ADDENDUM NO. 2

April 29, 2026

WILLIAM T. KEETON
HOUSE NORTH WING
STRUCTURAL
REPAIR & WATER
INFILTRATION
MITIGATION

SSK-02

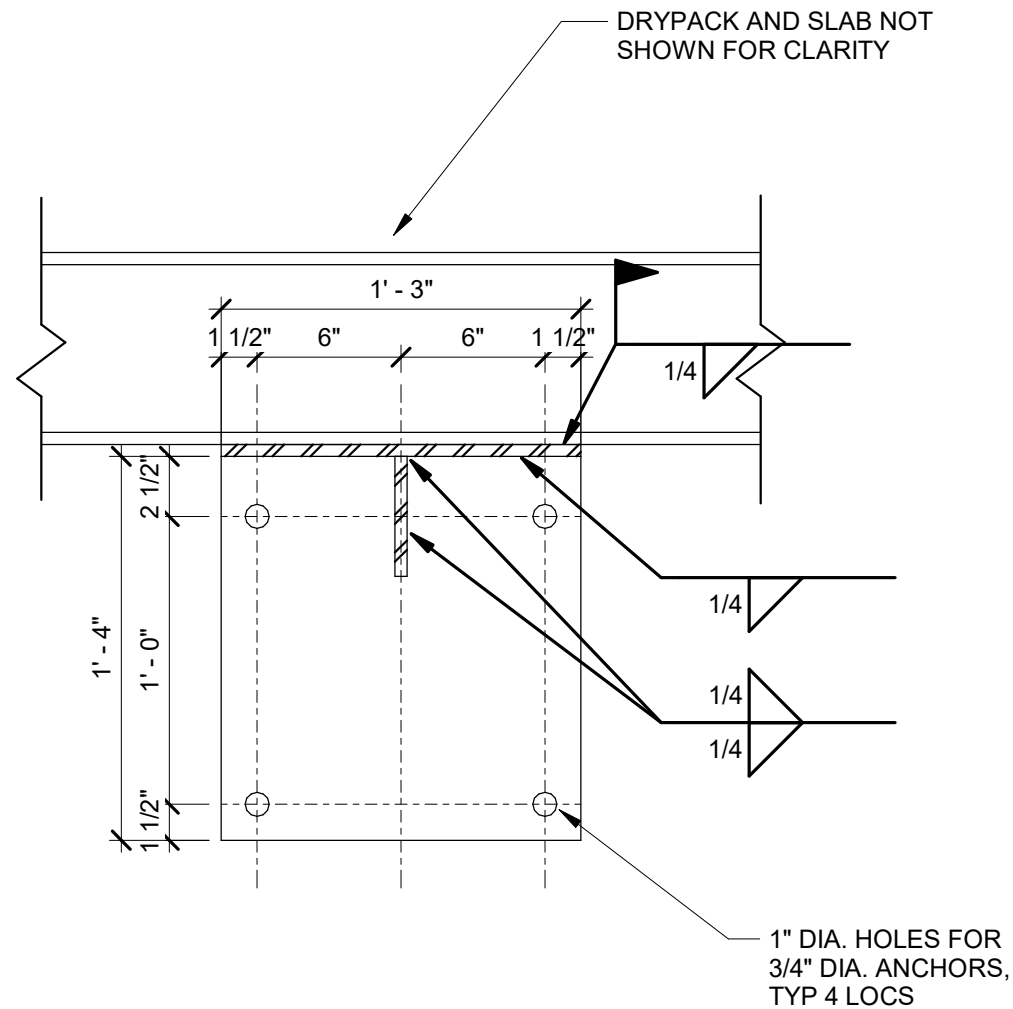
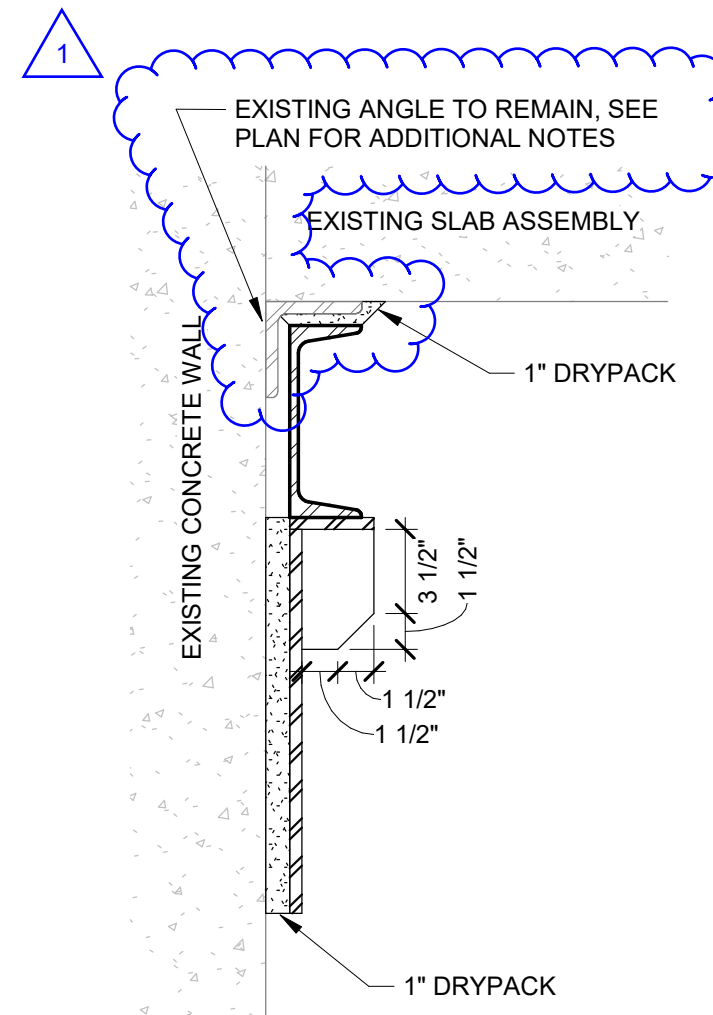
Item 1. Drawing AS-501, Detail 2

DELETE Detail 2 - BEAM SEAT DETAIL in its entirety.

REPLACE with Sketch SSK-02 - BEAM SEAT DETAIL, attached.

1. ALL PLATES ARE 1/2" THICK.
2. POST-INSTALLED ANCHORS ARE 3/4" DIAMETER X 8" LONG SS THREADED RODS EMBEDDED 4" WITH EPOXY ADHESIVE
3. DRYPACK SHALL HAVE MIN. COMPRESSIVE STRENGTH OF 5000 PSI
4. COORDINATE NEW ANCHORS WITH EXISTING REBAR LOCATIONS. CONTACT EOR TO LOCATE REBAR IN WALL PRIOR TO FINALIZING DETAILS AND SUPPORT LOCATIONS. INSTALL 11-1/2" 3-1/4" X 1/8" STEEL PLATE SHIMS IF NEEDED BETWEEN BEAM AND BEAM SEAT

SSK-03
17759908

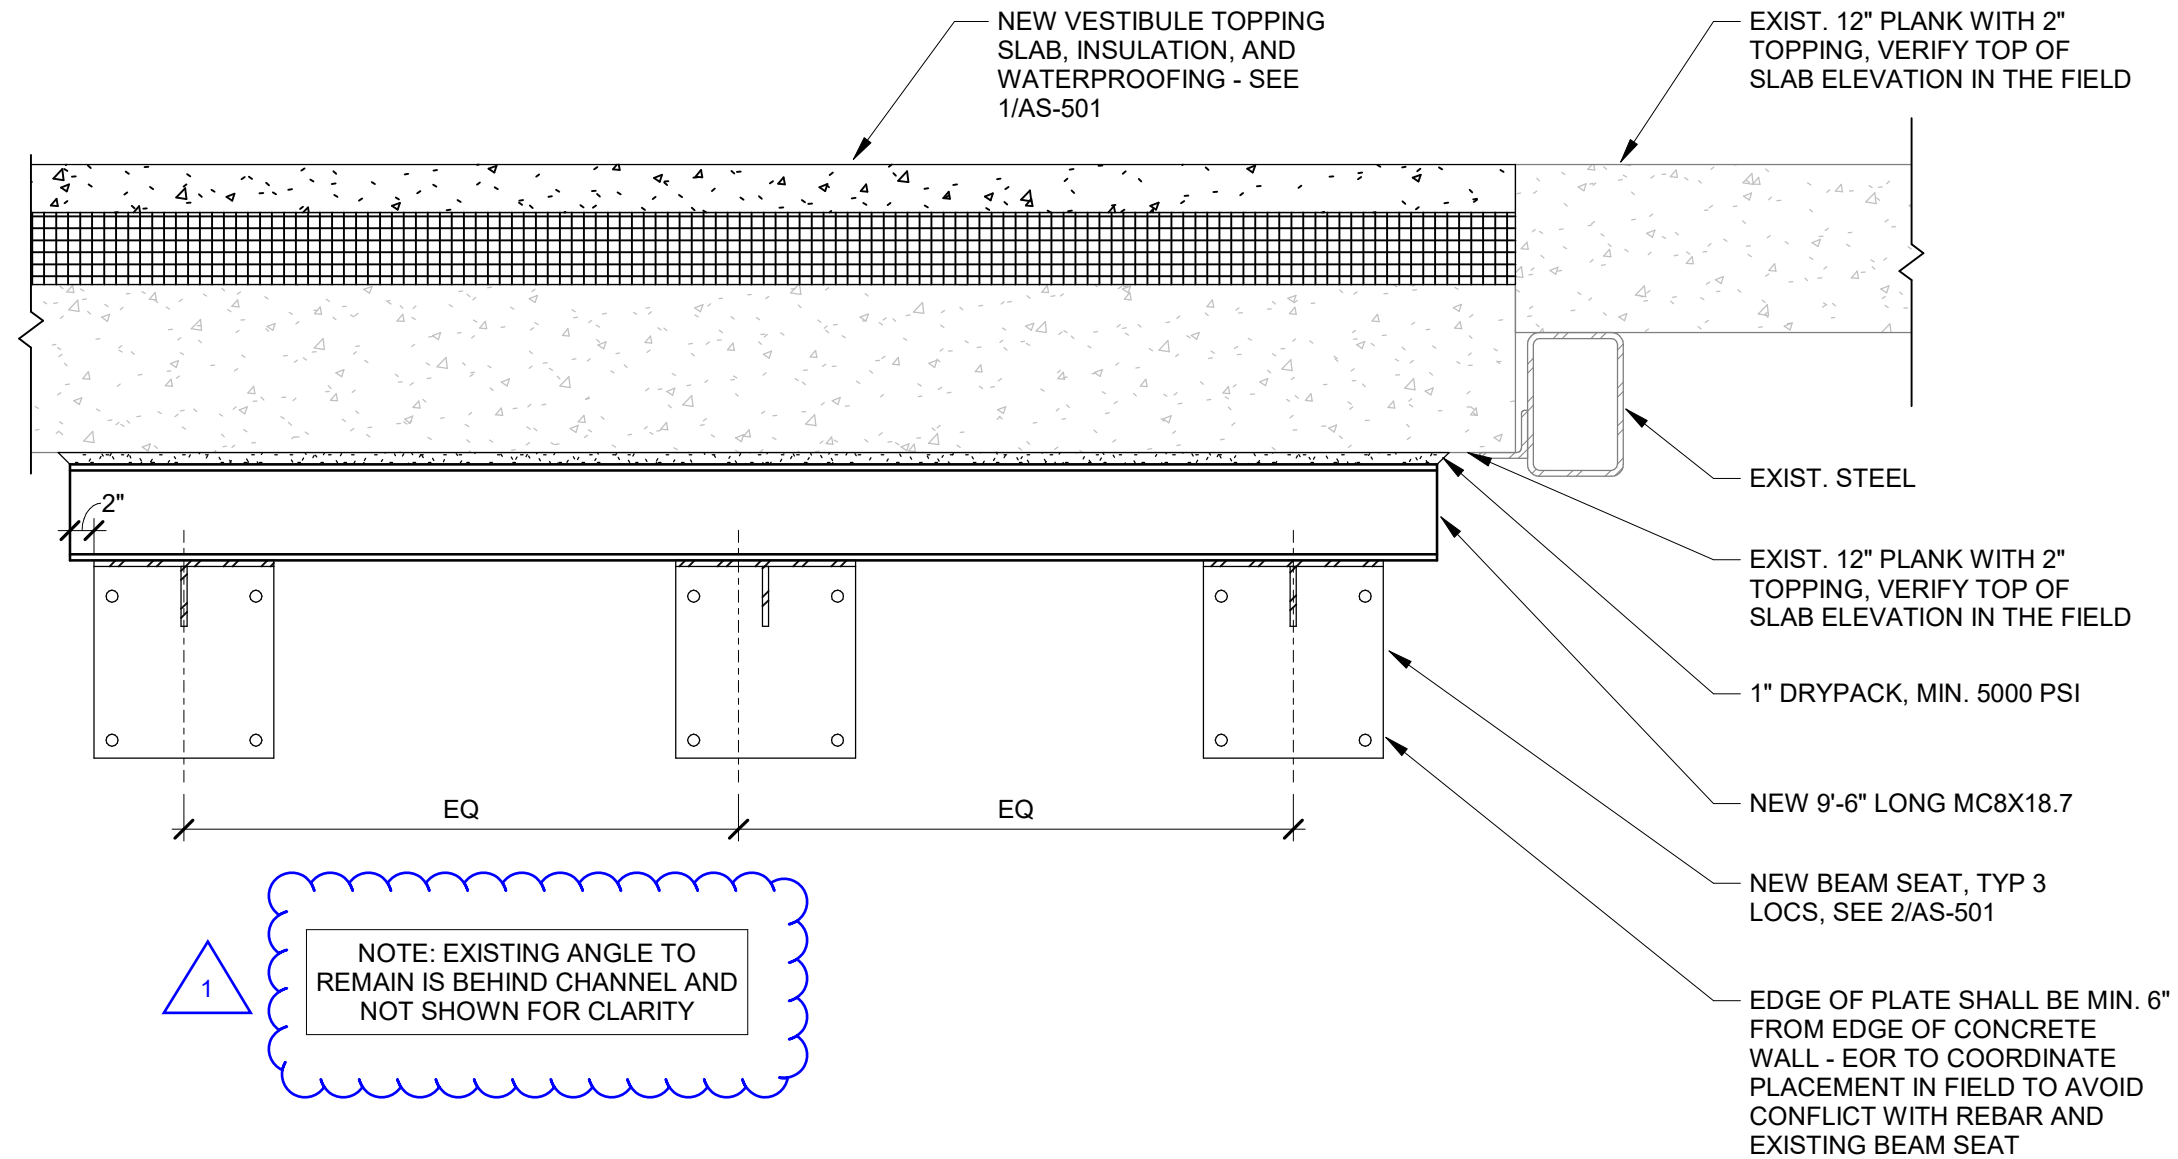
Item 2. Drawing AS-501, Detail 4

DELETE Detail 4 - PLANK SUPPORT DETAIL in its entirety.

REPLACE with Sketch SSK-03 - PLANK SUPPORT DETAIL, attached.

NOTE: EXISTING ANGLE TO
REMAIN IS BEHIND CHANNEL AND
NOT SHOWN FOR CLARITY
